Planning Applications Sub-Committee

SUPPLEMENTARY PACK 4

Comments from Statutory Consultees

4. **SITE COMPRISING LIVERPOOL STREET STATION, 50 LIVERPOOL STREET, SUN STREET PASSAGE, 40 LIVERPOOL STREET (IN PART), HOPE SQUARE AND BISHOPSGATE PLAZA LONDON, EC2M 7PY (25/00494/FULEIA AND ASSOCIATED LISTED BUILDING CONSENTS 25/00474/LBC, 25/00479/LBC, 25/00475/LBC, 25/00476LBC AND 25/00477/LBC)**

Figure 12: Plan view of 7th floor showing façade types

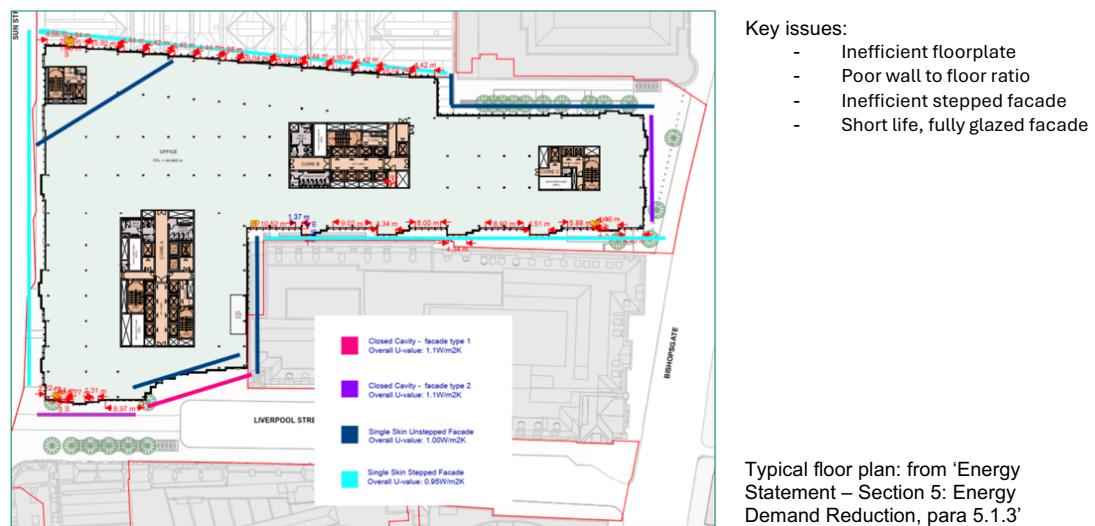
- The typical floor plan shown below (Submission 'Energy Statement – Section 5: Energy Demand Reduction, para 5.1.3') shows that the fully glazed facade is also inefficient in terms of wall to floor ratio. Apart from the inherently sub-optimum shape, the continual stepping of the facade adds to the overall surface area of the building, increasing material, i.e. embodied carbon costs, and is also consequently unhelpful to heat loss/gain. A more efficiently designed facade from both material and shape perspectives would contribute to greater facade longevity and improved operational performance. This floor plan cannot therefore be said to be 'exemplary' (see para 8.4 below, ref City Plan 2040 para 1.4)

5.6. **Comment:** This facade solution is not "An optimised façade responding to the external environment, with external shading" (LSSt Sustainability Statement March 2025 para 1.3.2.2) as claimed, and is as explained above, not a sustainable design approach in both embodied carbon and energy use terms. This is particularly concerning in the face of a climate crisis and the government's legally binding target of achieving Net Zero by 2050, and improved energy efficiency. The City's stated objective is to achieve Net Zero by 2040. The first facade replacement would be in about 2066, i.e. 16 years after 2050, and 26 years after 2040. It is very likely that given the current direction of continually tightening environmental legislation, and parallel ESG concerns by occupiers, that double glazed, all glass facades will no longer be possible for regulatory or commercial reasons. Will the structural solution be able to support a different, possibly heavier, long life facade solution when the building is vacated and refurbished in 2066, 2096 etc? **This building is therefore likely to be obsolete on completion.**

Demolition Site Plan – Extract from Dwg: A-04-200

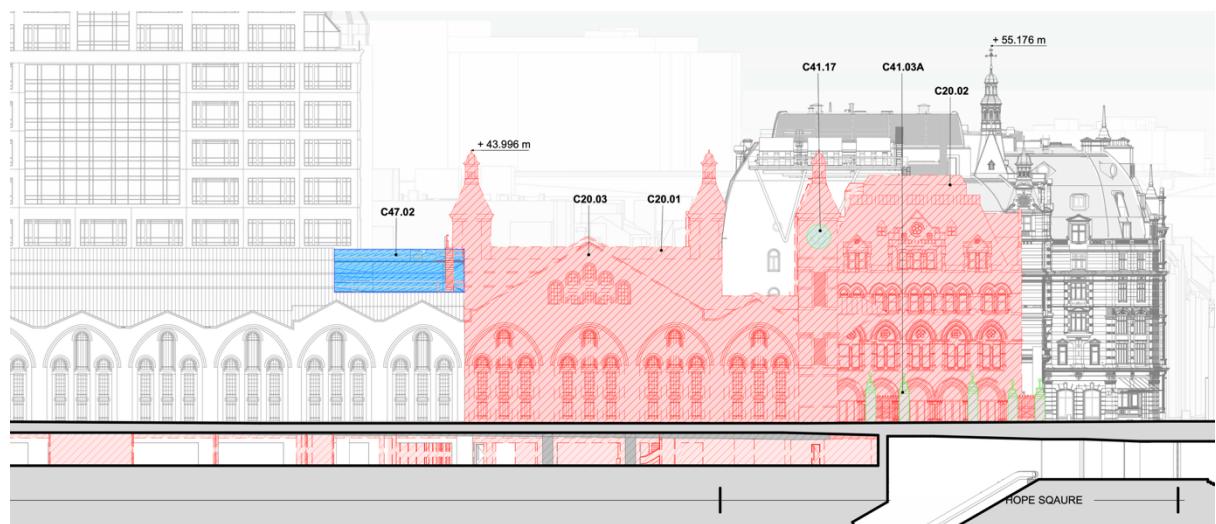
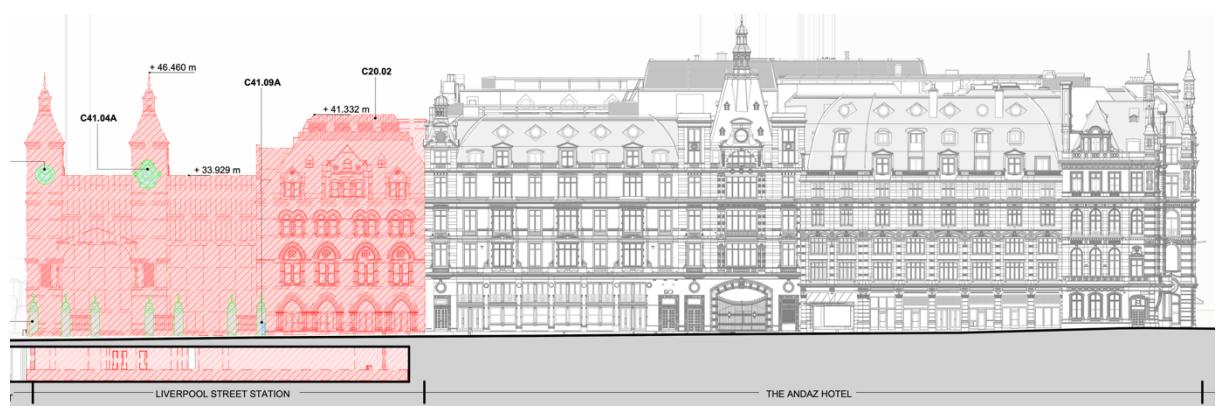
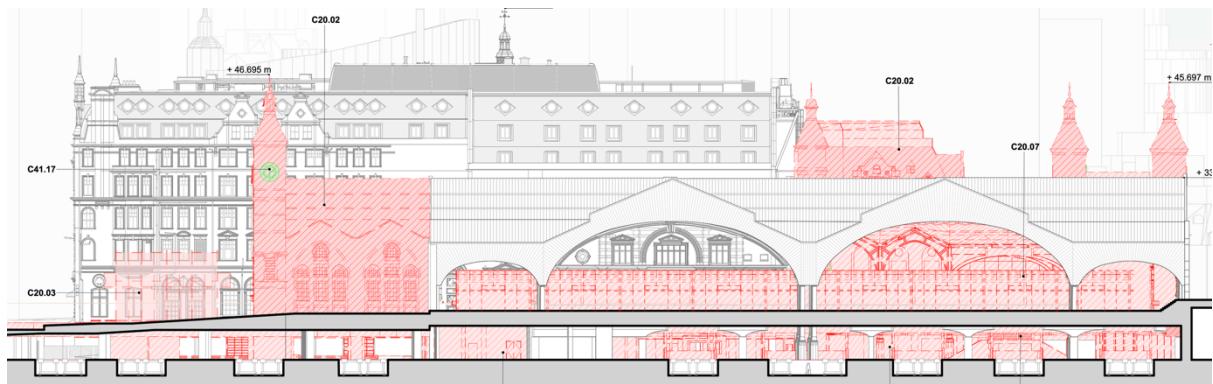
7.2. The proposed demolitions are extensive and predominantly involves fabric that has not reached the end of its useful life. Fabric and buildings subject to demolition are therefore entirely capable of retention and reuse. The concerns with respect to demolition are specifically associated with the buildings that face onto Liverpool Street and Bishopsgate.
